# ADDENDUM NO. 1

**June 13, 2024**

## **PORTER COUNTY HIGHWAY DEPARTMENT – CENTRAL FACILITY**

This Addendum consists of Page ADD 1-1 through ADD 1-4, revised Specification Section 00 20 00 – Information Available to Bidders, attached Addendum No. 1 from A & Z Engineering, consisting of 1 page and 8 drawings, and attached Addendum No. 1 from MartinRiley, consisting of 4 pages, Specification Sections 00 01 10 - Table of Contents, 07 42 13 – Metal Wall Panels, 07 71 00 - Roof Specialties, 10 28 00 - Toilet, Bath, and Laundry Accessories, 11 11 19 - Vehicle Lubrication Equipment, 23 31 00 - HVAC Ducts and Castings, 41 22 00 - Hoists and Cranes, and 13 Drawings.

**2** Gutter  
3" = 1'-0"

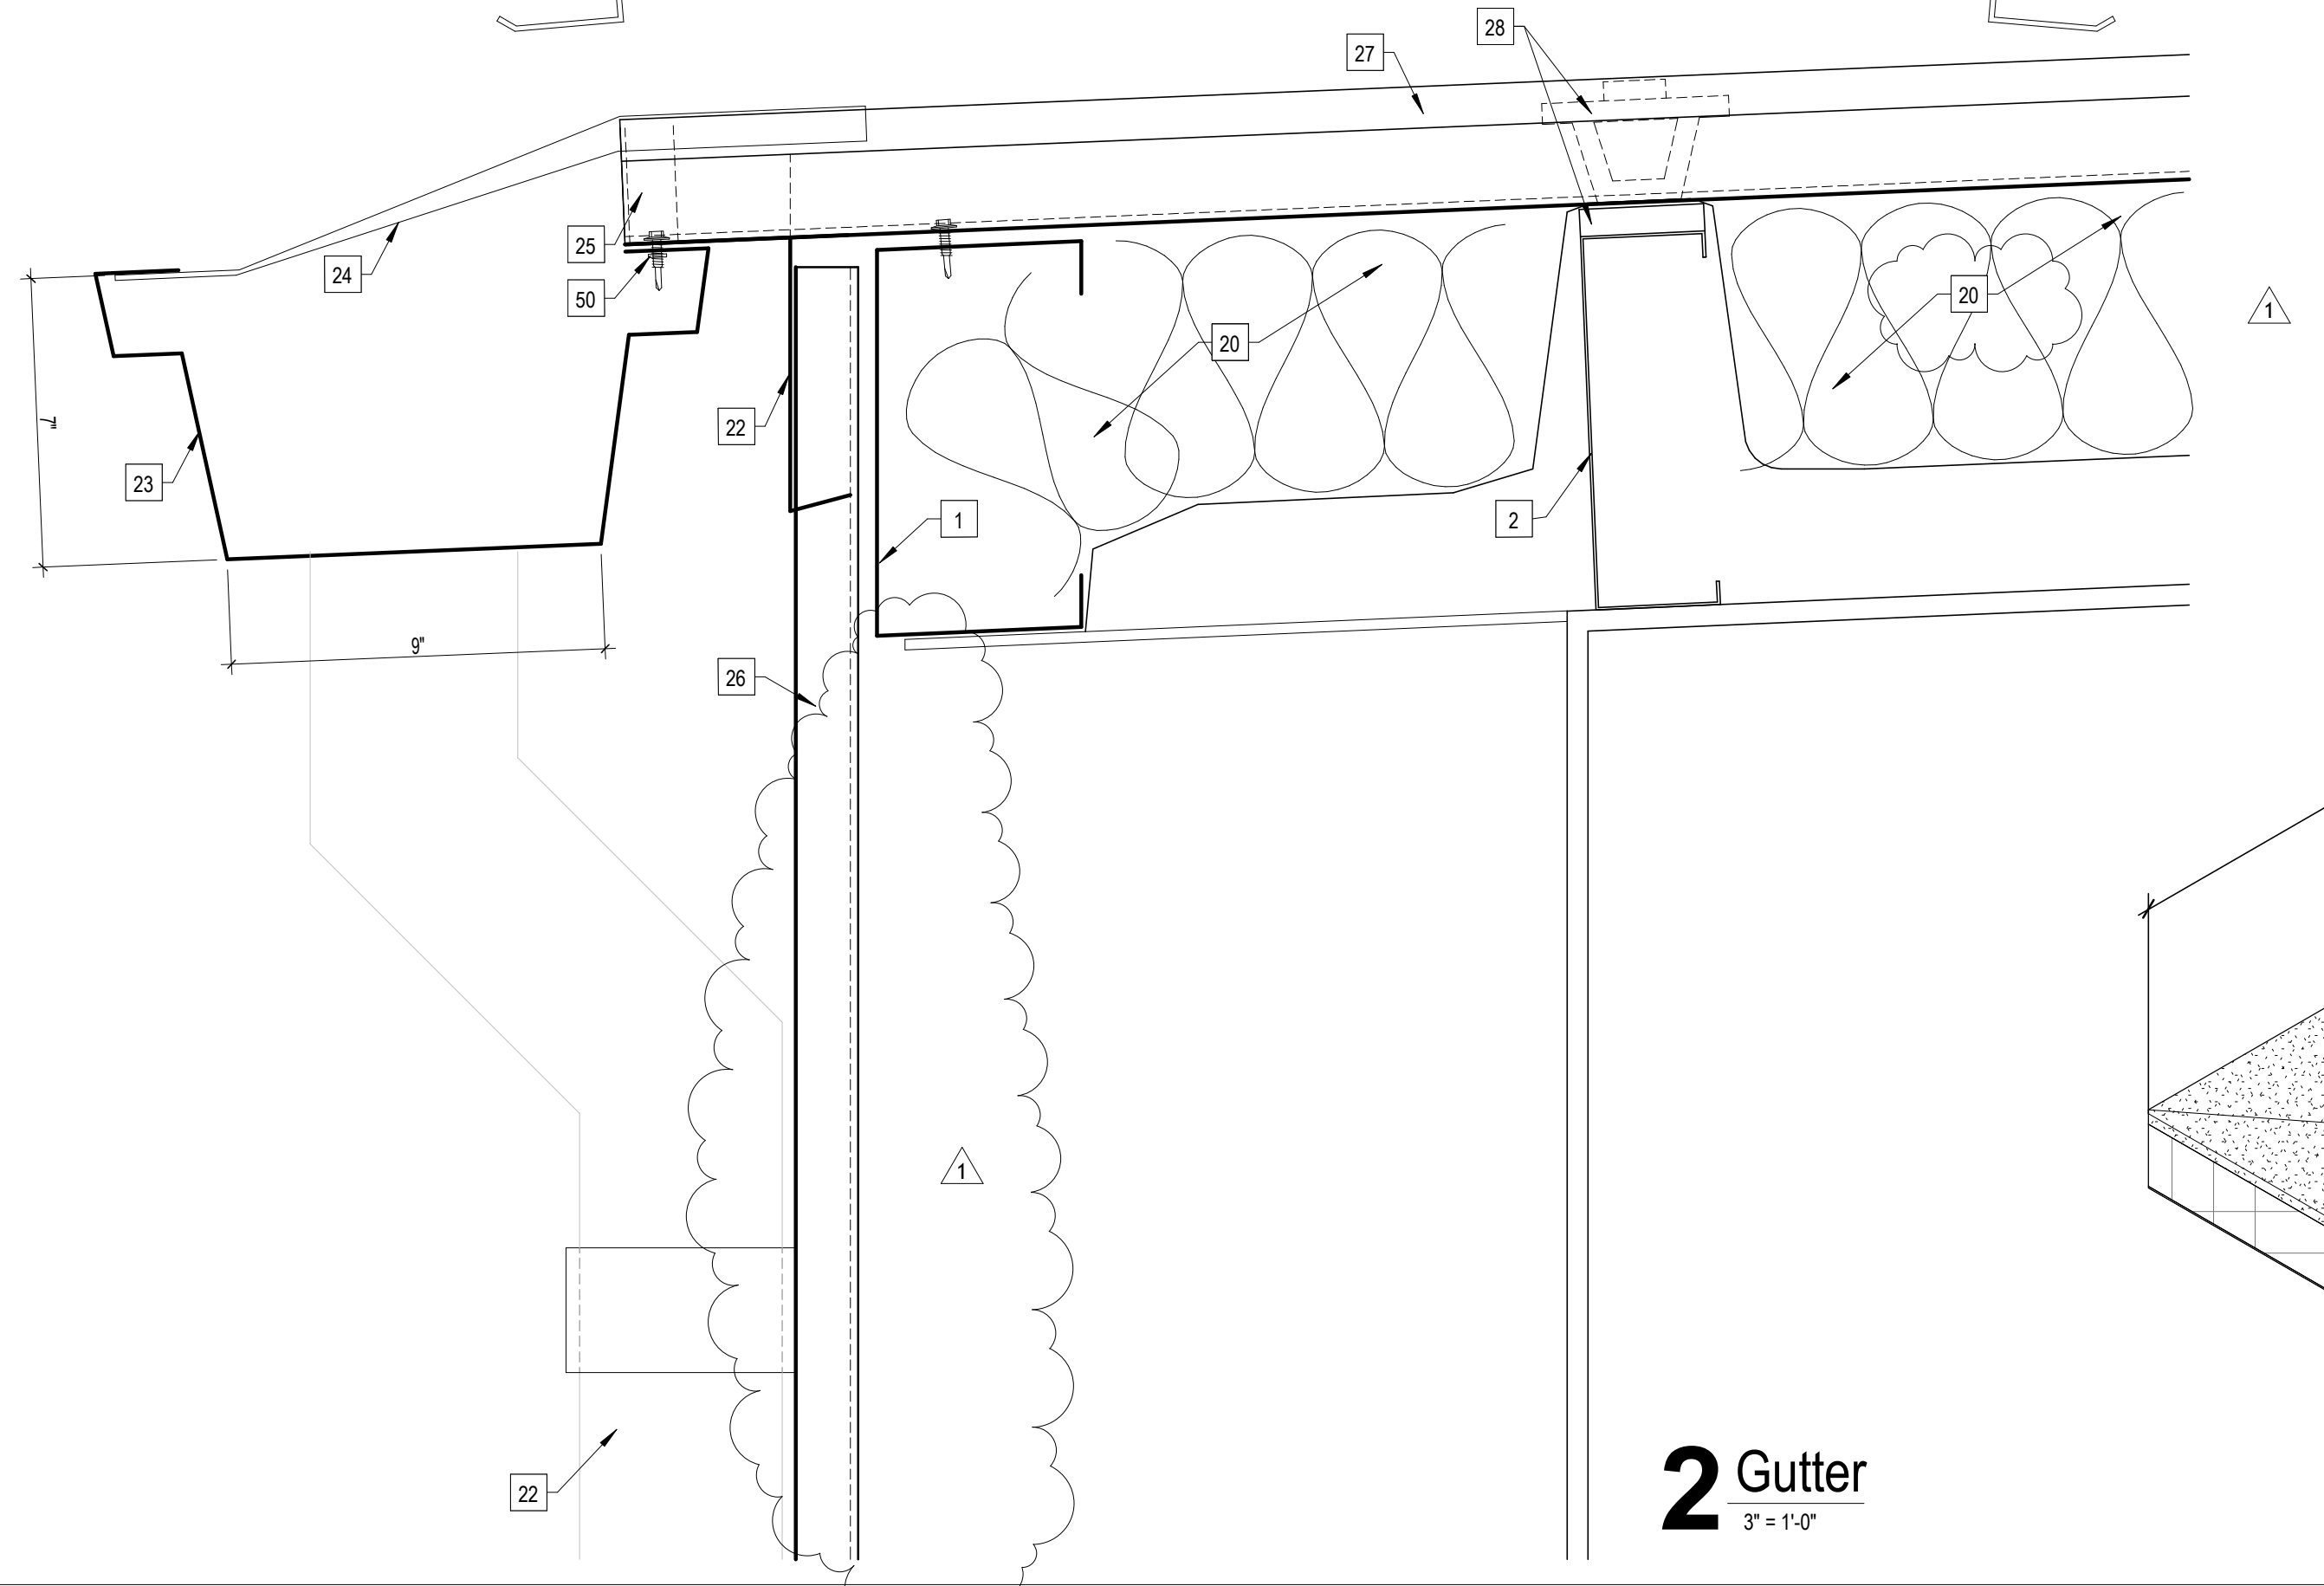
Sheet R201 Roof Details **MODIFY** Detail 2 to indicate Work Description Note 20 at all roof insulation locations.

Sheet R201 Roof Details **MODIFY** Details 2 and 3 to remove blanket wall insulation.
